Keyer Accessory kit mandatory mod

March 4, 2022

Jackson Harbor Press

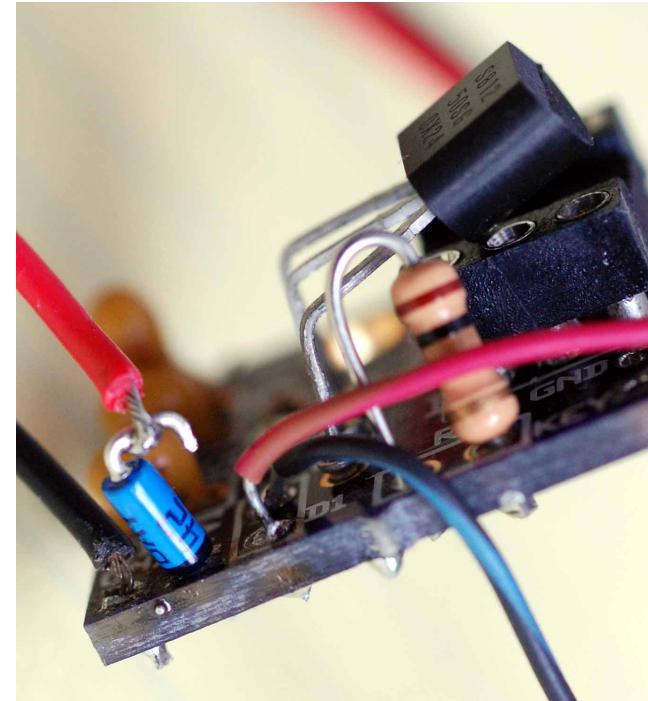
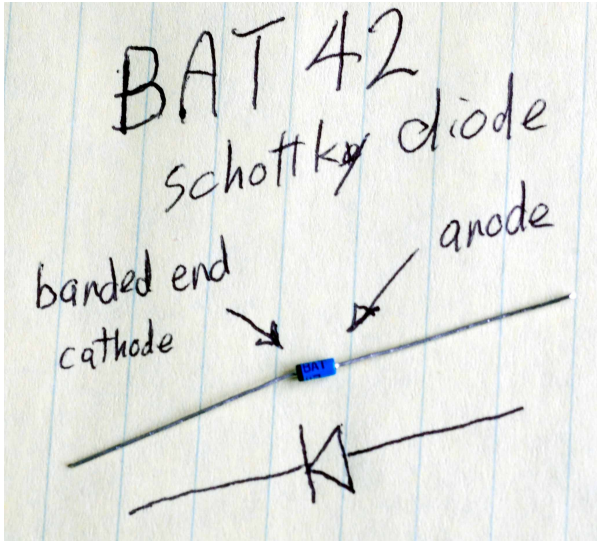
BAT42 diode now included with kit

Install the BAT42 as shown in series with the positive lead from the battery. Note the banded end is connected to the board and the anode is connected to the battery. The LED was removed via the red and black-blue wires.
